TECHNICAL BULLETIN

MODEL/DERIVATIVE:
Discovery Series II
Defender

Bulletin N°: 0025
CDS. ref: L8658bu
Issue: 1
Date: 09.05.01

OIL LEAKAGE FROM THE CAMSHAFT COVER TO CARRIER JOINT

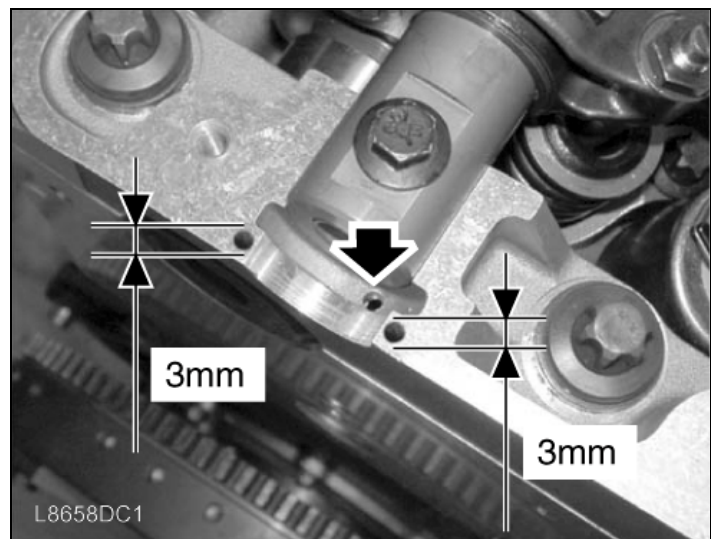
Oil leaking through the camshaft cover joint at the gasket 'D' section to the rear of the fuel injector rocker shaft.

The rear acoustic cover foam pad becomes saturated with oil which eventually runs down the rear of the engine to drip from the engine back plate/gearbox bell housing.

At VIN 1A 297400 (Discovery II) and 1A 603700 (Defender), an operation to apply sealant to the rear of the camshaft carrier was introduced during manufacture.

This process should also be used for all future repairs where the camshaft cover to carrier joint is disturbed.

- Prior to fitting the new gasket, apply two 3mm diameter beads of sealant STC50551 to the camshaft carrier in the locations shown in the illustration.

Use of excessive sealant can result in blockage of the oil drain hole in the lower centre of the 'D' shaped cut out, (arrowed in illustration).
